SUBJECT: Site Plan Modification Review for 1213 Barlow Road
The Wallhouse Inn - Hudson

PC Case No: 2015-16

Aerial Overlay Exhibit

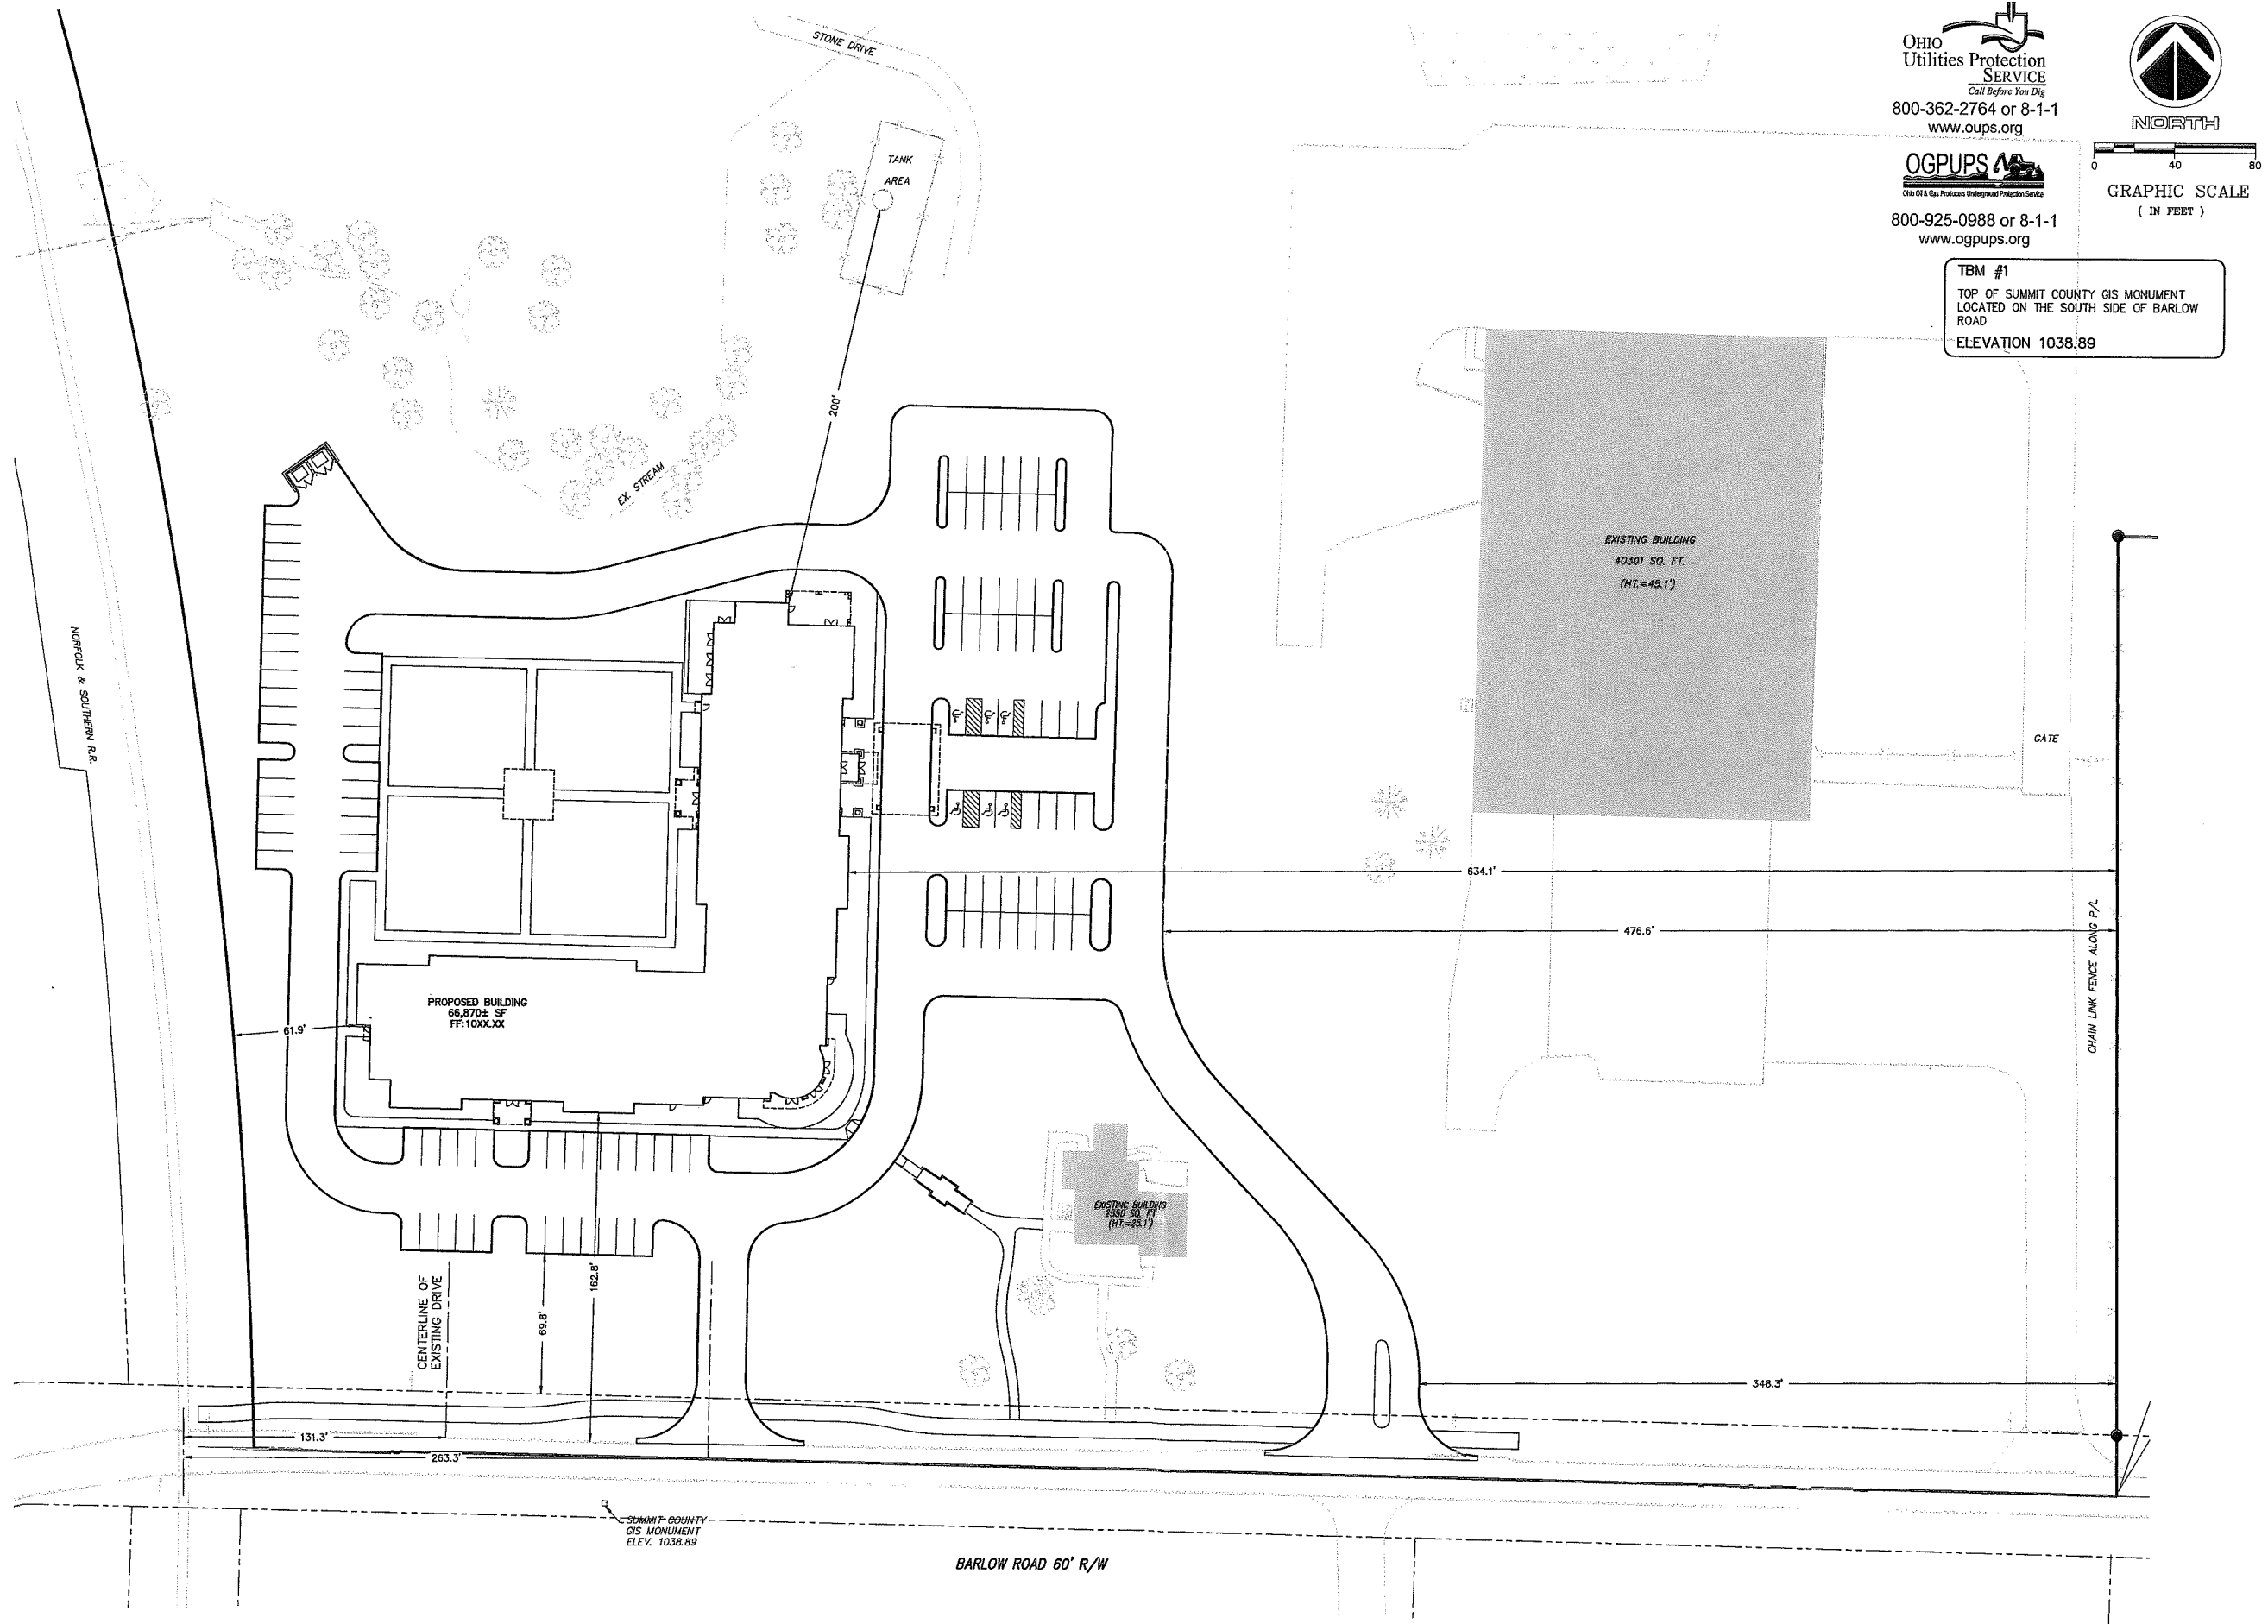
Proposed: An access point aligned with the Heritage of Hudson was previously approved. A second access 330 feet further west is proposed.

Applicant requests that the Planning Commission modify its approval to allow addition of the west driveway as a right turn in/ right turn out access to and from the site.

The City of Hudson Engineering Department has no concern with the second driveway provided a raised vertical curbed island with the proper radii and proper signage/markings is approved by the City Engineer. The driveway shall conform to the Ohio Dept. of Transportation Location and Design Manual 401-13ae or 401-13be (as applicable) for rural roadways (uncurbed w/o right turn lane) and the detail shall be included in the plans/construction at the property owner's expense to establish a permanent right-in right-out driveway at this location. The developer shall also coordinate the design/construction of these site improvements with the design & construction of the proposed City of Hudson Improvement Project that is currently under design for Barlow Road by the City's consultant.
